## SOLICITATION AMENDMENT MODIFICATION DE L'INVITATION

<b>Title - Sujet</b> Mountain Kiosks for Seismic Equip	
<b>Solicitation No. - N° de l'invitation</b> 23490-170668/A	<b>Amendment No. - N° modif.</b> 002
<b>Client Reference No. - N° de référence du client</b> 23490-170668	<b>Date</b> 2016-11-24
<b>GETS Reference No. - N° de référence de SEAG</b> PW-\$VIC-249-7111	
<b>File No. - N° de dossier</b> VIC-6-39133 (249)	<b>CCC No./N° CCC - FMS No./N° VME</b>
<b>Solicitation Closes - L'invitation prend fin</b> <b>at - à 02:00 PM</b> <b>on - le 2016-12-27</b>	
<b>Time Zone</b> Fuseau horaire Pacific Standard Time PST	
<b>F.O.B. - F.A.B.</b> <b>Plant-Usine:</b> <input type="checkbox"/> <b>Destination:</b> <input checked="" type="checkbox"/> <b>Other-Autre:</b> <input type="checkbox"/>	
<b>Address Enquiries to: - Adresser toutes questions à:</b> Cress, Christine	<b>Buyer Id - Id de l'acheteur</b> vic249
<b>Telephone No. - N° de téléphone</b> (250) 363-8442 ( )	<b>FAX No. - N° de FAX</b> ( ) -

**This Amendment 002 to the Solicitation is raised to address Bidder inquiries and to attach insurance requirements at Annex C.**

Polystyrene Foam Board Insulation

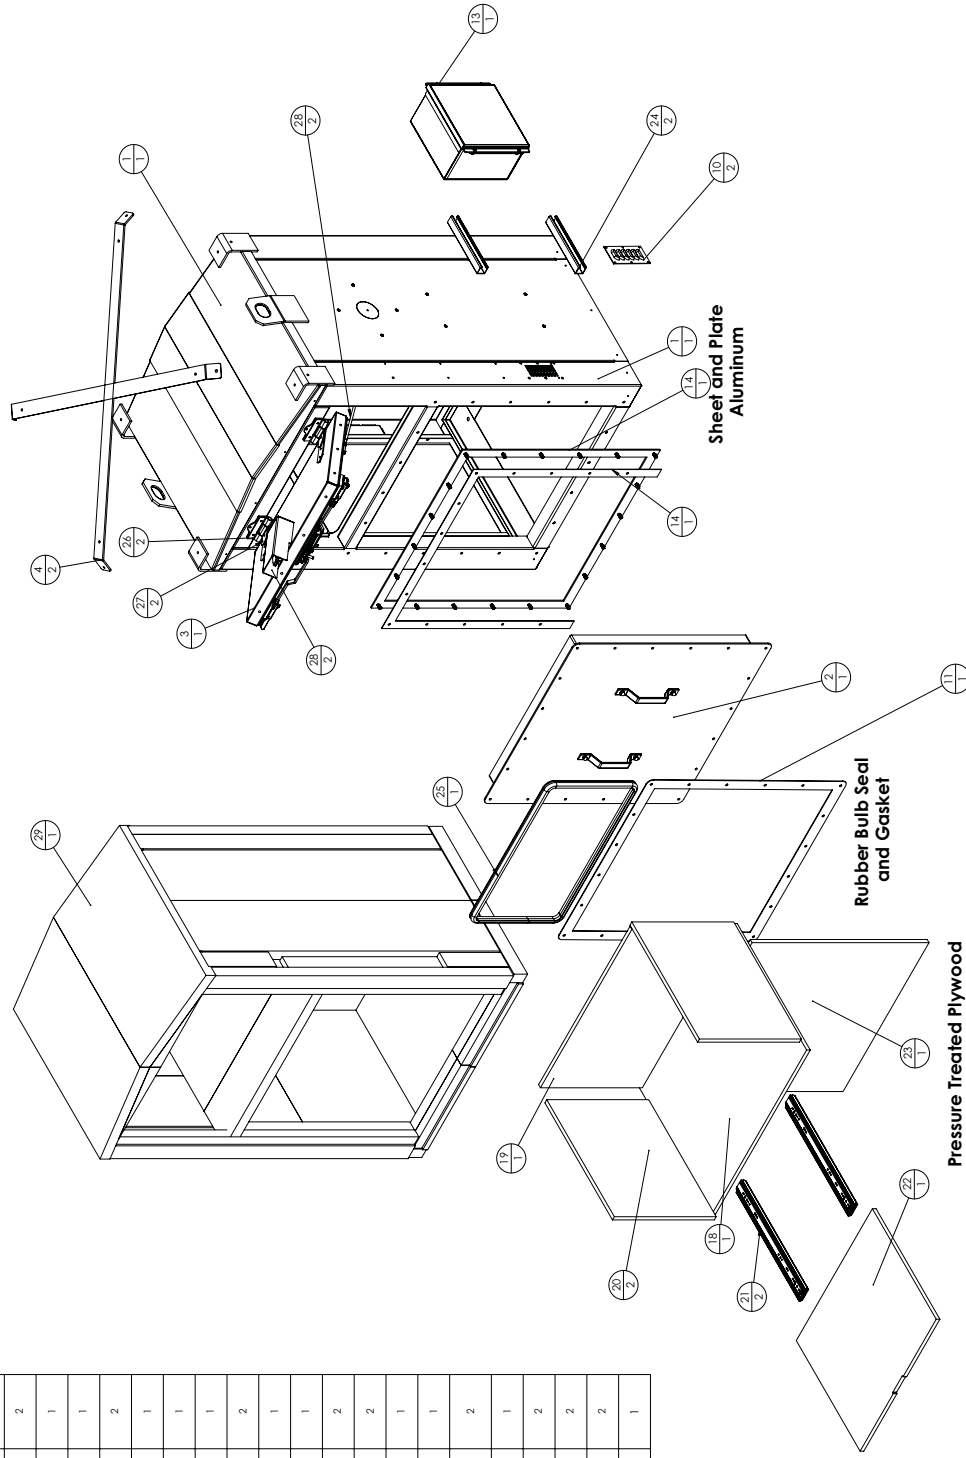
Drawing CMTK201

- This appears to be a welded assembly with no insulation. However, the hatch and Instrument door are insulated. Is that correct?

The components are listed on page 2 in the bill of material, however there are no detail drawings for these. Are these drawings available?

Drawing CMTK202 and CMTK203

- The components are listed on page 2 in the bill of material, however there are no detail drawings for these. Are these drawings available?

- Hardware items have part numbers, but no manufacturer/ Supplier name. Can this information be provided?

The assembly is joined in a composite method using some welded joints, through-bolted panels and captive PEM style nuts and some blind rivets.

All joints must be watertight using weld, sealant bedded joint or rubber seal/gasket.

The entire assembly is insulated using 2" thick polystyrene foam board insulation cut into specific shapes. (refer to attached Overview assembly drawing MTK204C)

See attached Overview assembly drawing MTK204C.

Yes, See attached Overview assembly drawing MTK204C. In general, off the shelf parts are from several suppliers including McMaster-Carr and Sierra Pacific, generic SAE hardware is specified as 316 stainless steel.

See attached Overview assembly drawing MTK204C.
